AGENDA
City of Gig Harbor Design Review Board
Virtual Meeting of April 8, 2021 at 5:00 pm

**COMMUNITY DEVELOPMENT DEPARTMENT
PLANNING DIVISION
STAFF REPORT**

RE: Canterwood Commercial Center (PL-SPR-07-0004, PL-CUP-13-0002, PL-DRB-07-0013, PL-SEPA-07-0060)
Public Meeting Date: April 8, 2021

TO: Design Review Board
FROM: Planning Staff – Kimberly Mahoney, Associate Planner
DATE: April 1, 2021

Design Standards Alternate Design Proposal for 17.99.240D

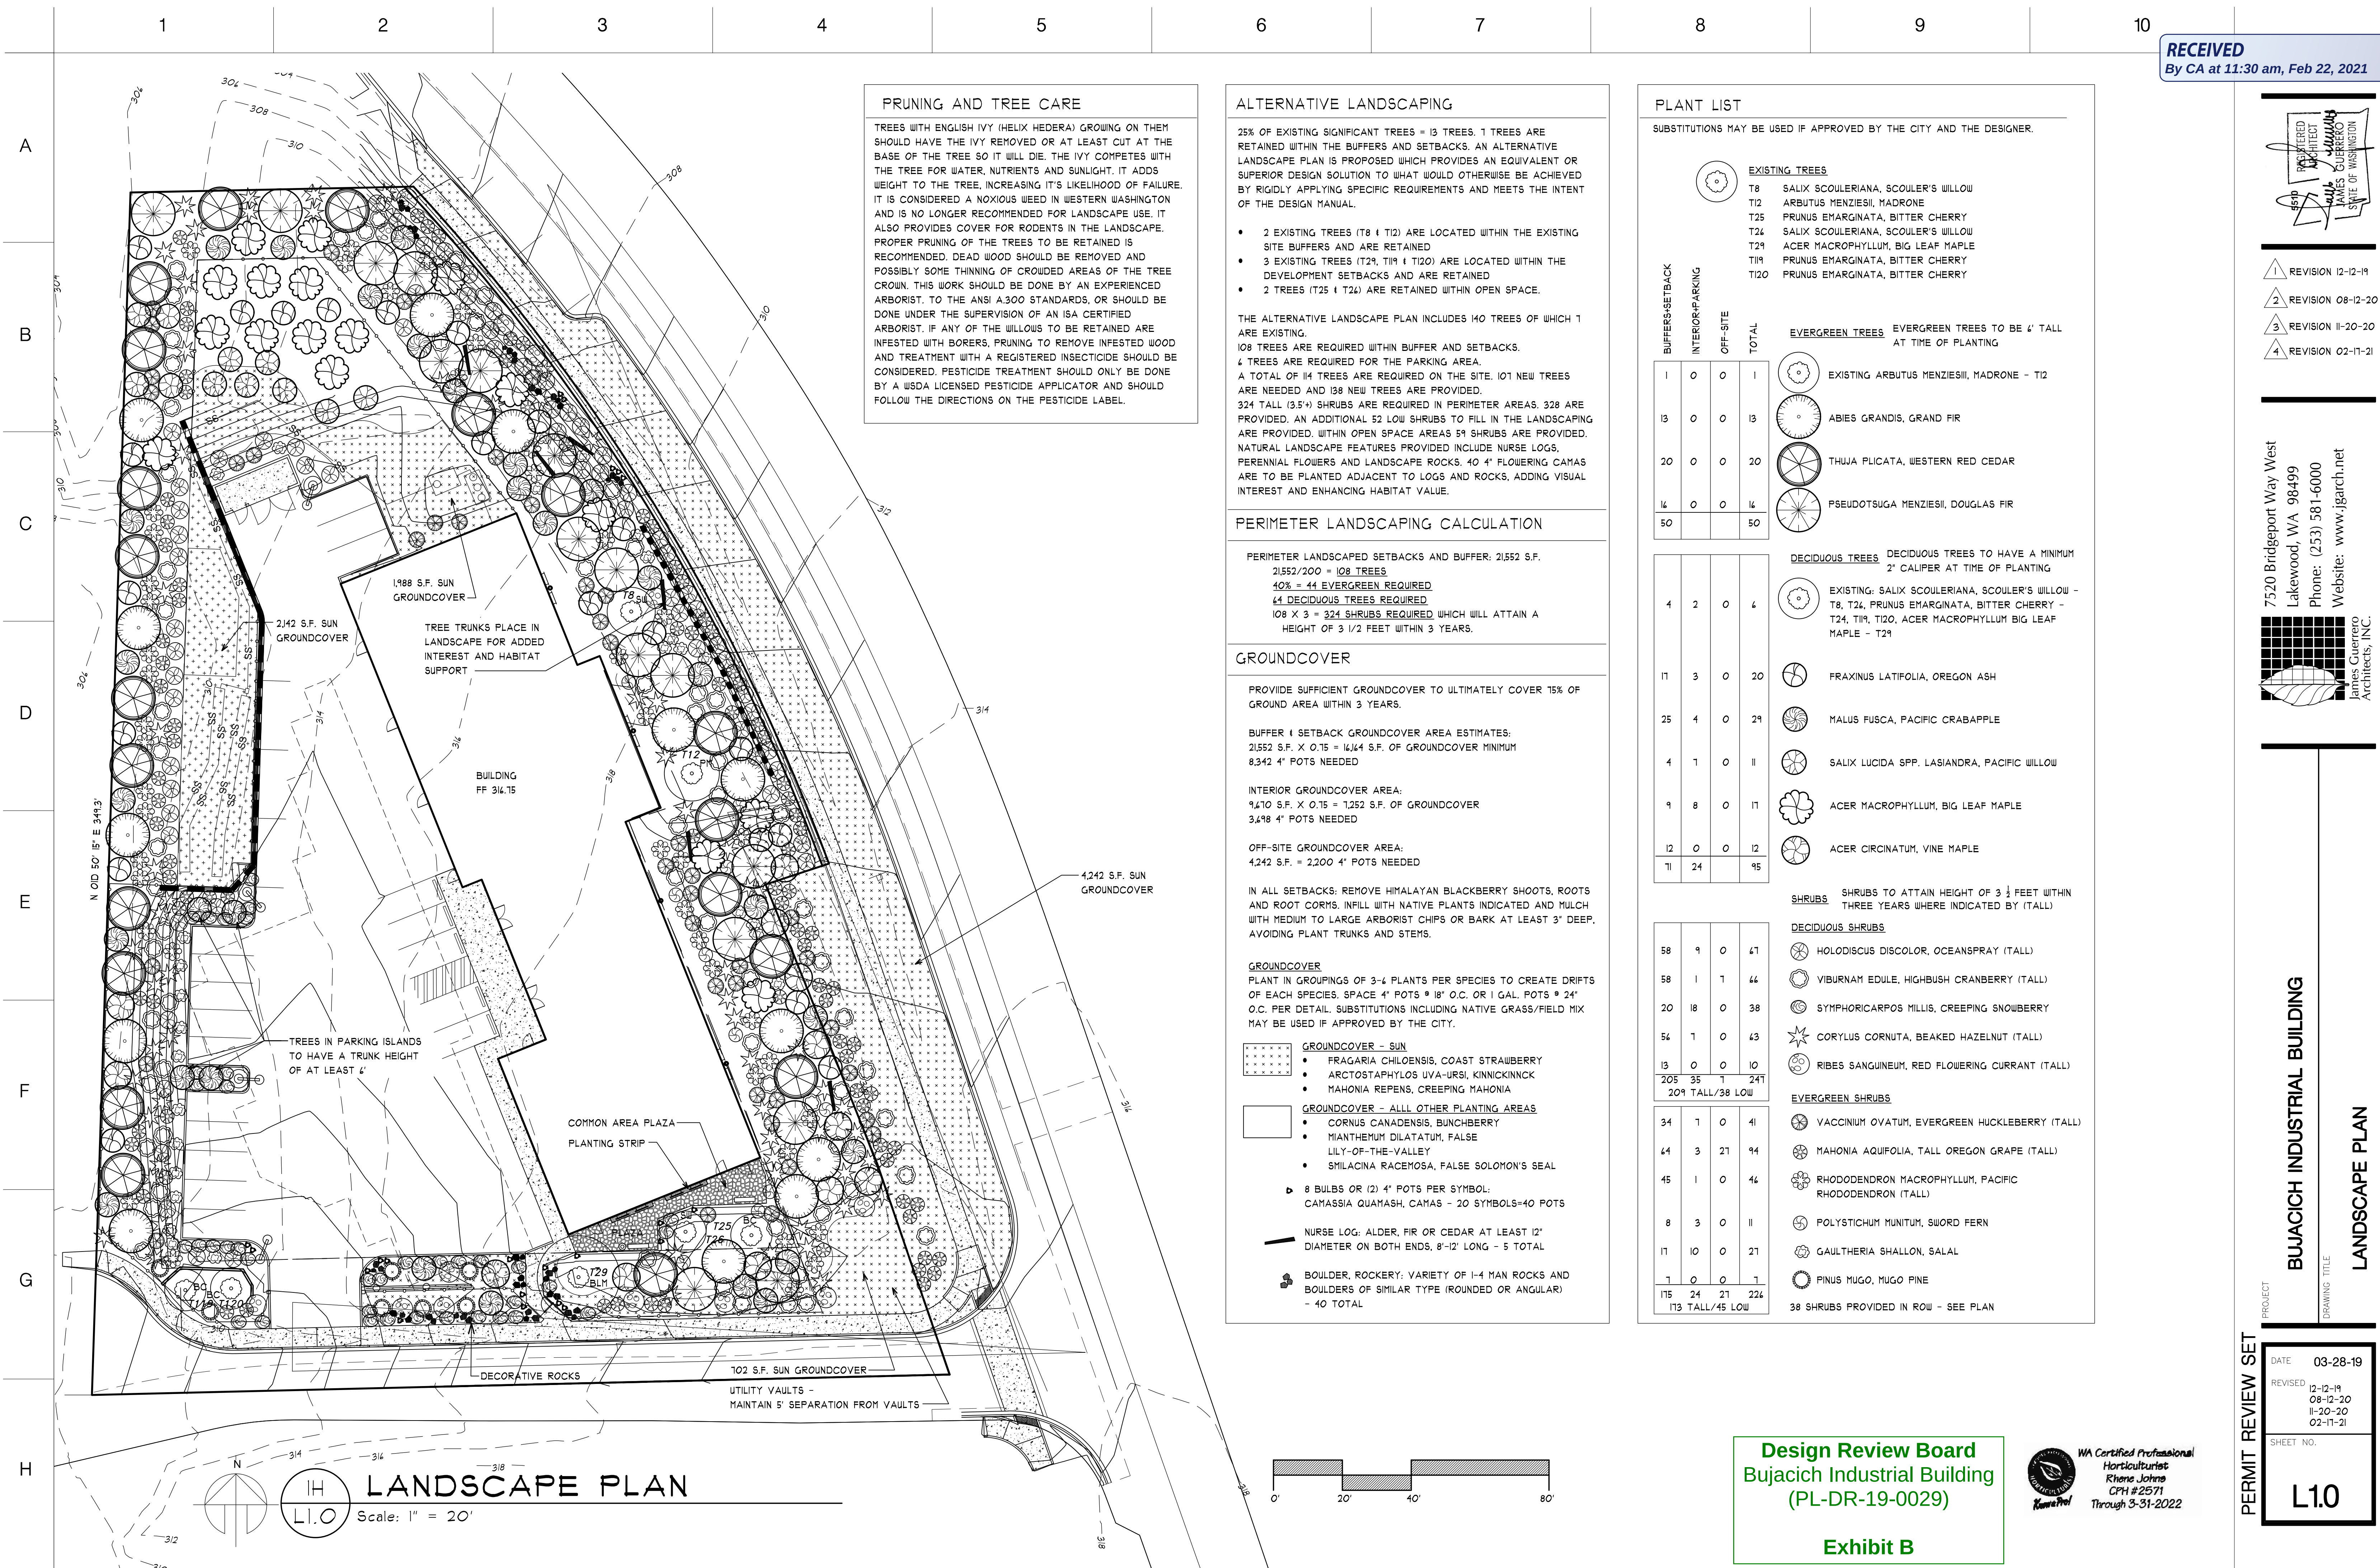
Code Excerpt 17.99.240D: Incorporate approximately 25 percent of significant trees into the project or approximately 15 percent for short plats. On nonresidential, multifamily sites, and residential subdivisions at least 25 percent of significant trees shall be incorporated into required landscaping and retained indefinitely. In short plats, at least 15 percent of significant trees shall be retained indefinitely. The percent calculation shall be based upon significant trees currently on the site and which have been cleared from the site within the past five years. All significant trees on site shall be identified and shown on a tree survey. In conjunction with the percent retention requirement, the following options may be applied to other landscaping requirements of this chapter.

The alternative design meets the intent of the general requirements of the Design Manual by enhancing the natural appearance of the site from public ways, softening and partially screening the building and maintaining the Gig Harbor aesthetic of thoughtful building design coupled with regional forest plants to maintain a unique sense of place in this beautiful part of the world.

TREE RETENTION PLAN

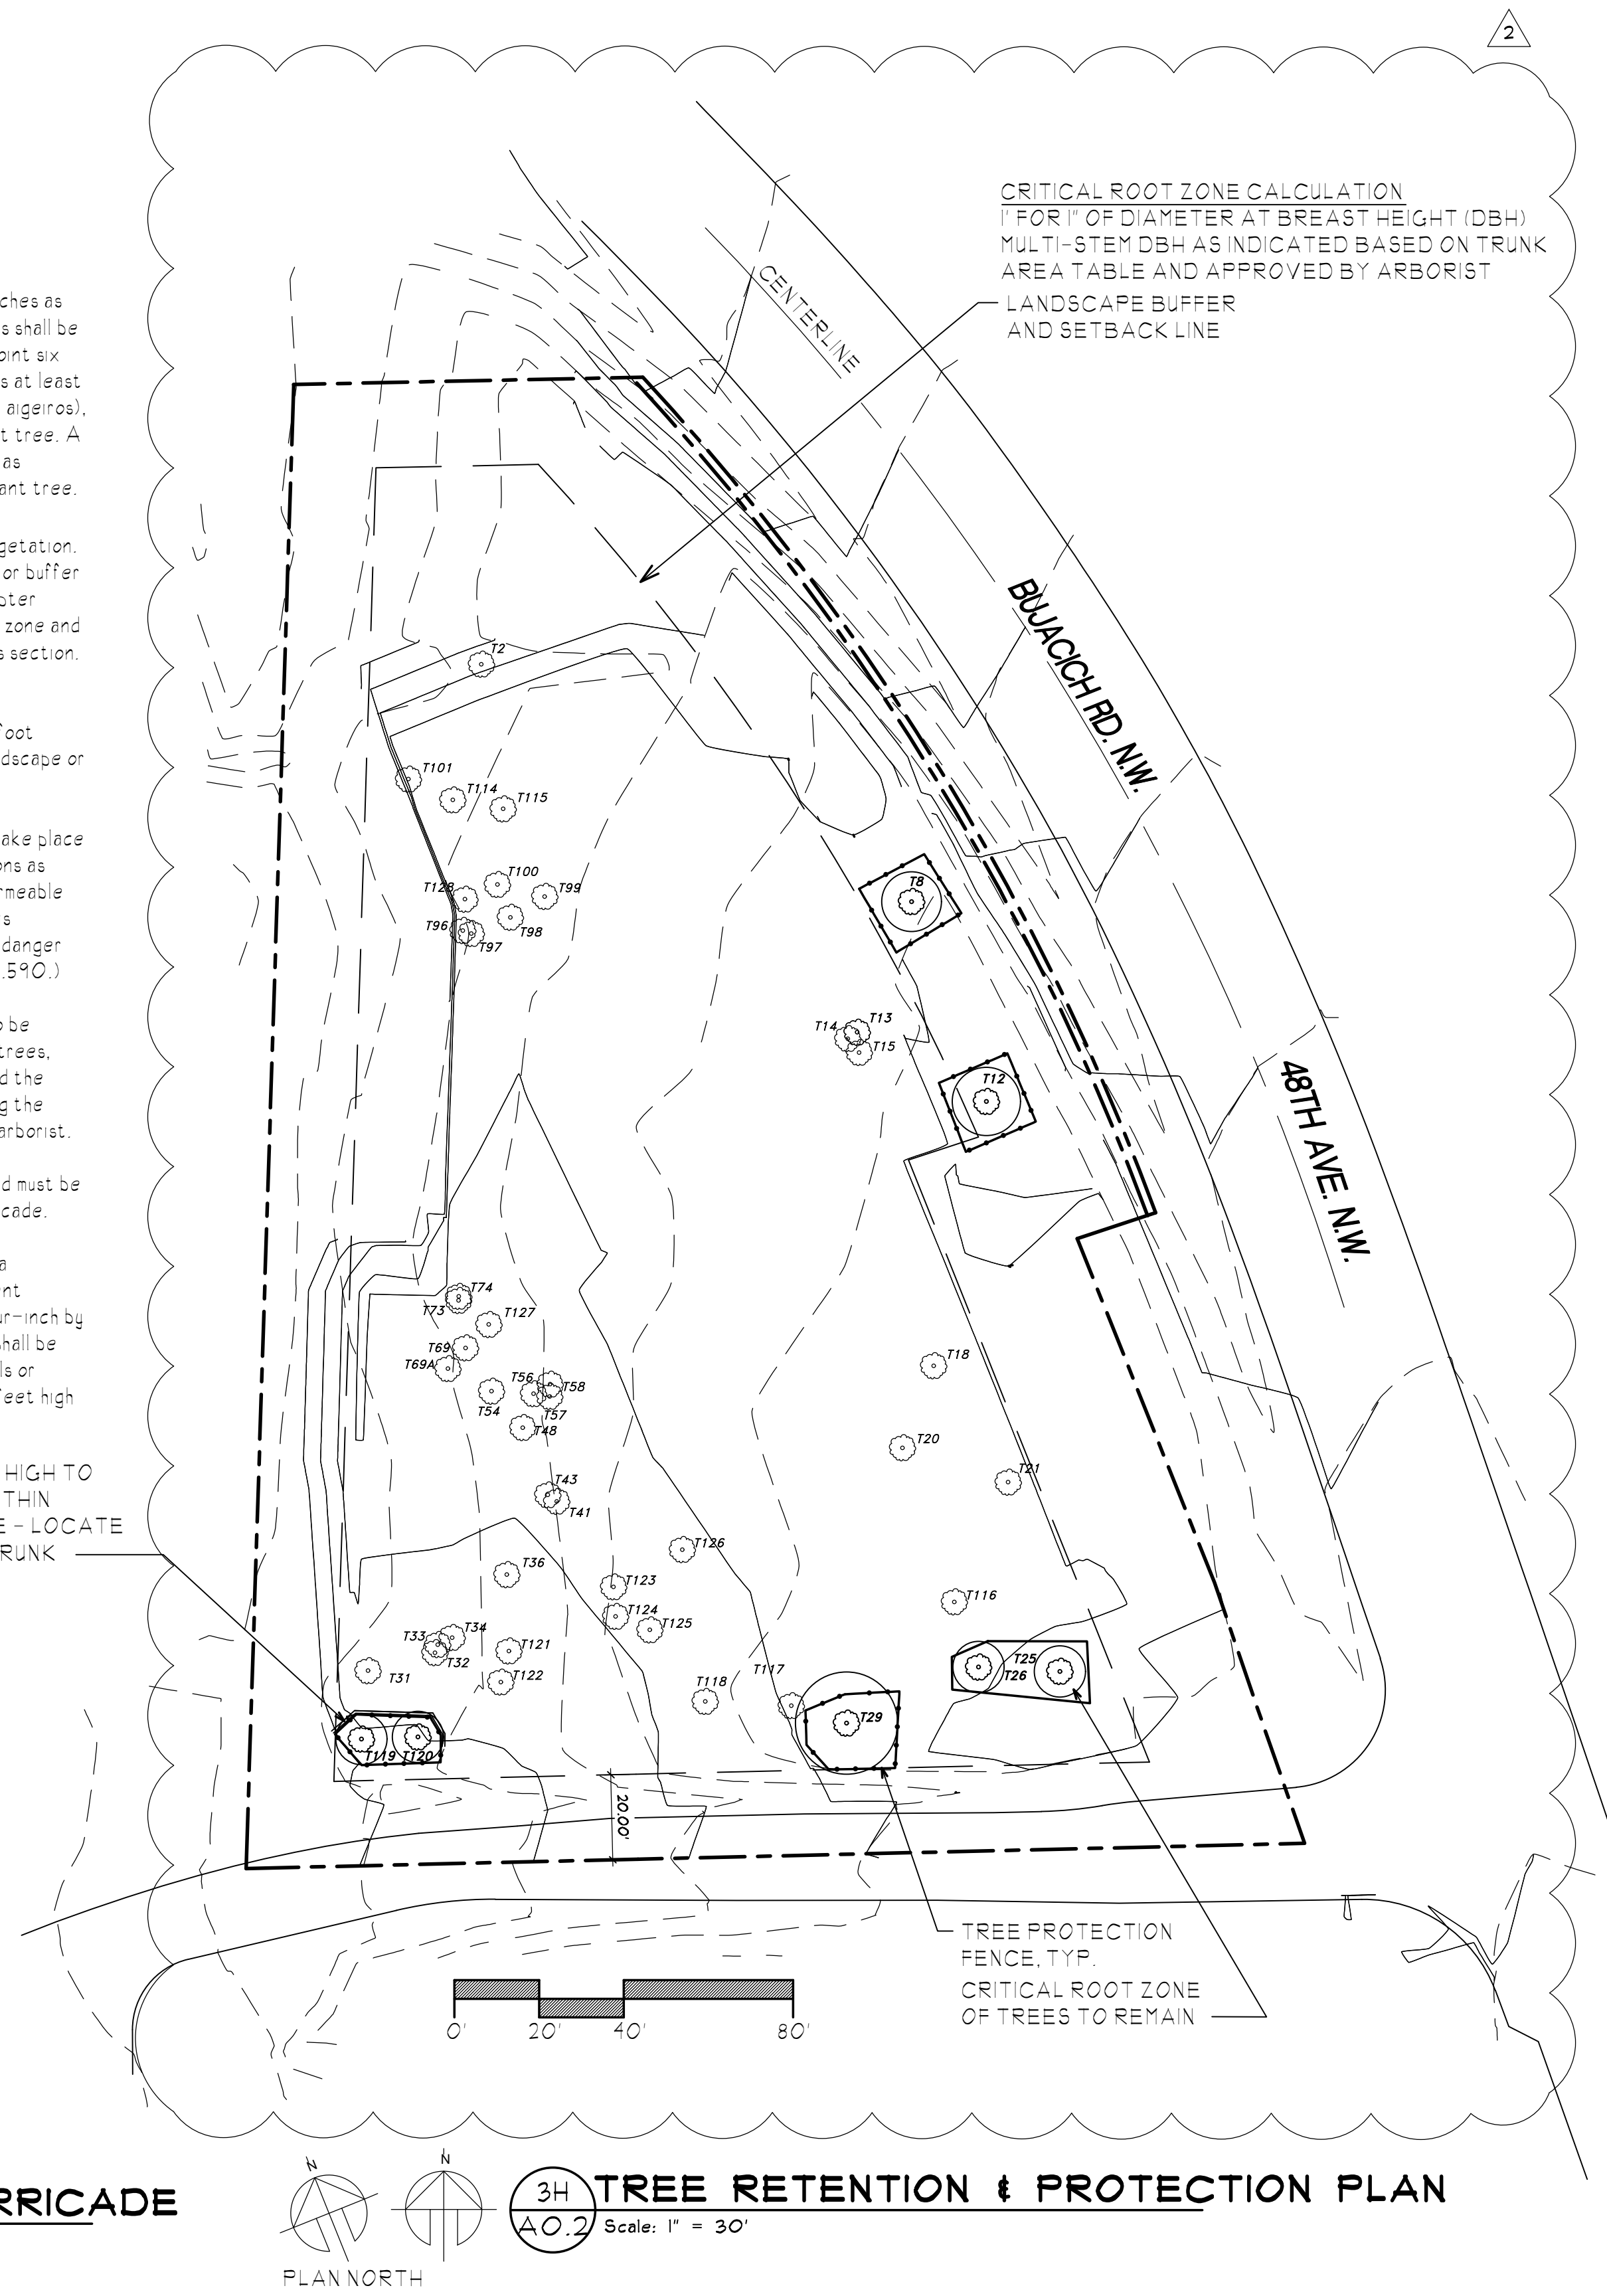
landscape the site with 30 additional trees than would be required through strict adherence with the landscaping requirements set forth in GHMC Chapter 17.78, Trees, Landscaping and Screening. These 30 proposed new trees consist of both deciduous and evergreen species; see Exhibit B included with this staff report to review the applicant's proposed Landscape Plan. Staff calculates that six (6) evergreen trees and 24 deciduous trees comprise the 30 new trees proposed for planting by the applicant; the evergreen trees are proposed to be planted at a height of 6-feet and the deciduous trees are proposed to be planted at a minimum of 2-inch caliper in size. All proposed new trees are of species which are native to the Pacific Northwest region and are listed on the Director's Preferred Species for Planting.

Given that the applicant's proposed alternative includes the installation of 30 new trees in place of the requirement to retain an additional six (6) existing significant trees, the DRB may wish to consider the sheer volume of plantings as meeting the intent of GHMC 17.99.240(D) and as achieving an equivalent or superior design solution that would be achieved through strict adherence to this Design Manual provision, particularly considering the mature size and codified preference of the selected native species. The DRB may further wish to consider the site's natural conditions as being predominantly dominated by deciduous significant tree species, and may find that the applicant's proposed alternative design incorporates a majority of deciduous tree species for installation, thereby respecting the natural conditions of the site.
